Planning & Zoning Board Regular Meeting

August 1, 2023 @ 6:00 pm

4. **Public Hearings**
(Public participation and comment on these matters must be in-person.)
 - a. [SPR #23-09. Request of Max Eliscu.](#) 10 minutes
Request of Max Eliscu for approval to construct a new, single-story, 748 square-foot cabana and a new, two-story, 1,001 square-foot addition to the existing single-family home located at 802 Georgia Avenue on Lake Osceola, zoned R-1AAA.

- b. [Request of Metro Winter Park, LLC: To amend the Comprehensive Plan Future Land Use designation from Institutional to Medium Density Residential to be consistent with the R-3 zoning of the properties and for Conditional Use approval for a two-story, 58-unit multi-family project on the properties at 821 & 831 W. Swoope Ave. and 800, 810 & 830 W. Webster Ave.](#) 60 minutes

TREE MITIGATION PLAN

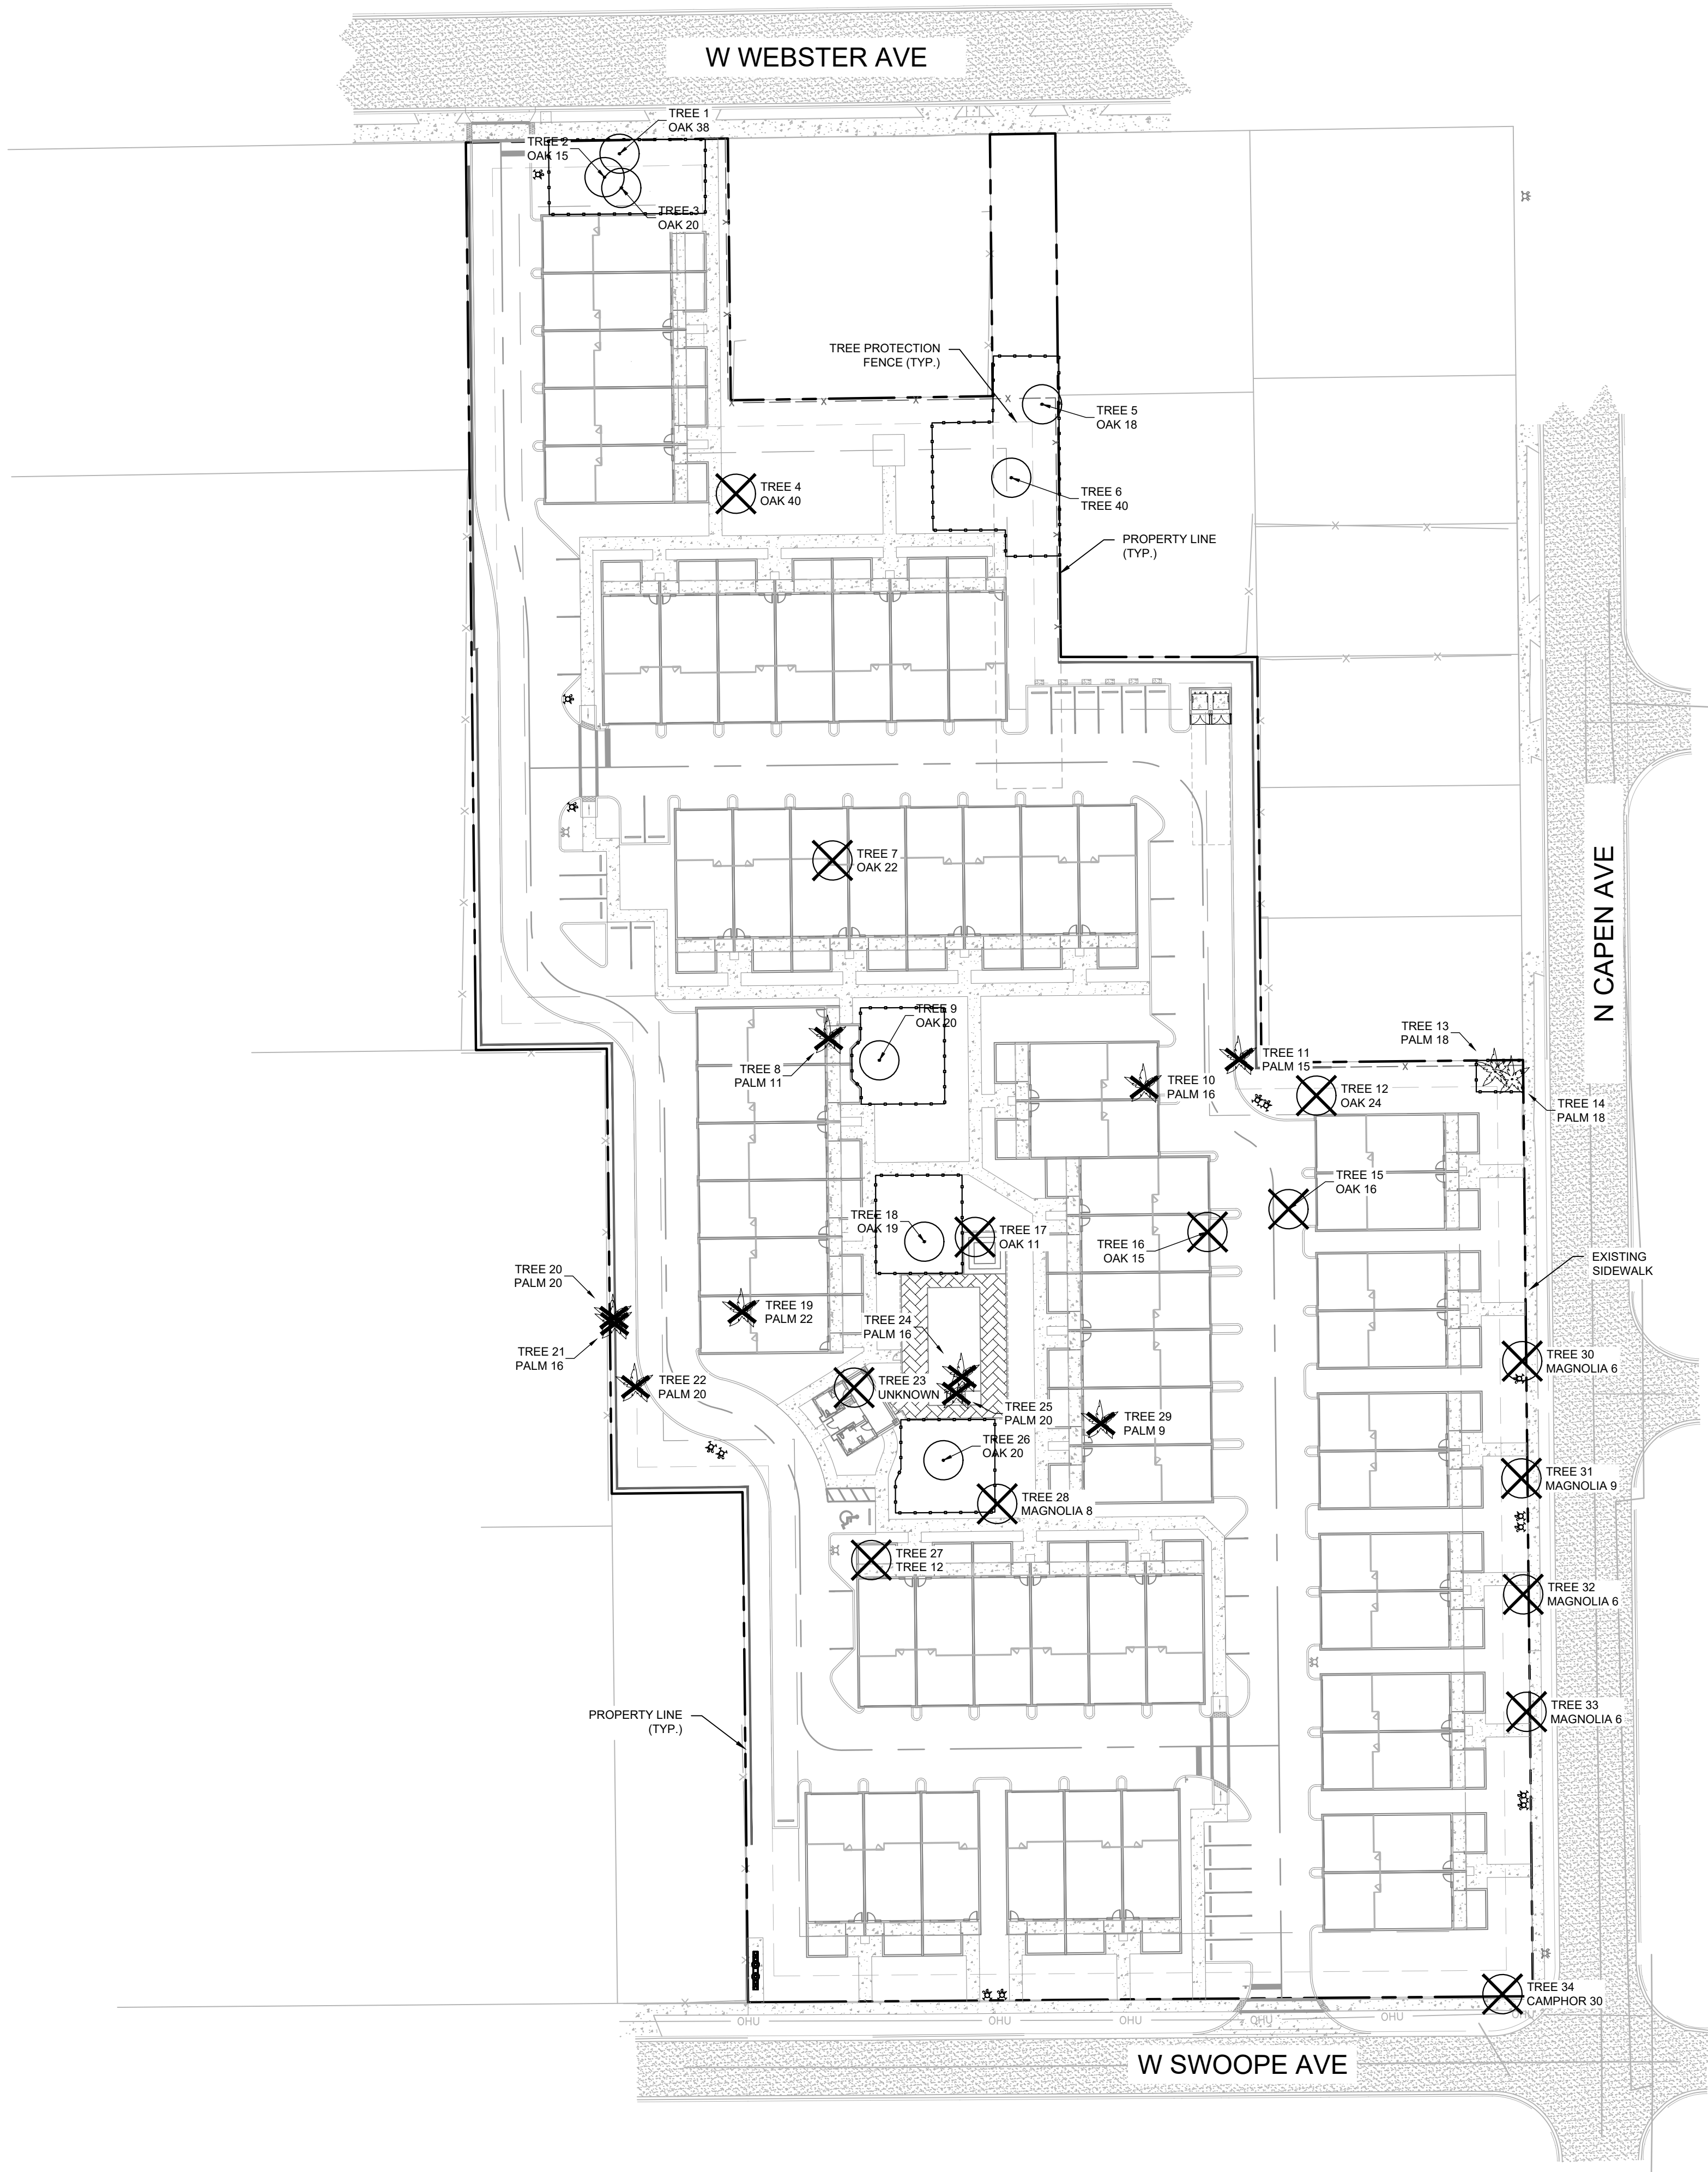
Conditional Use standard #6 states that “the topographical and natural features of the site shall be given priority consideration, thus assuring the retention of trees”. On this 4.51-acre site, there are just four mature healthy live oak trees that need to be given priority consideration and preserved. One tree sits on a northern property line in the setback area where it is not in jeopardy. However, the planning staff and urban forestry have issues with the way the applicant is attempting to preserve the other three trees.

The other three specimen live oak trees are clustered in the area proposed for the project amenity of the swimming pool and clubhouse. The City has requested is a 20-foot separation from any improvements to the trees in order to preserve the tree canopy and root system immediately adjacent to these trees. Twenty feet is comparable to the width of two parking spaces. The applicant is proposing to provide only 10 feet of separation which is comparable to the width of one parking space, from the trunk of these three healthy live oak trees. Once beyond that 10 feet, the applicant is proposing to trench for foundation footers, construct buildings, trench for retaining walls, build patio decks and the swimming pool/pool deck. The conflicts are obvious. Ten feet away from one live oak, the branches are touching the walls/windows of a townhome building. Ten feet away from two live oaks is the swimming pool deck and pool water with tree limbs extending out over the pool water and tree root systems that are guaranteed to be lifting up the pool deck and patio decks causing such recurring problems that the project owner will certainly want the live oak trees removed. But that is unlikely to happen, because these three live oak trees will not survive those construction impacts.
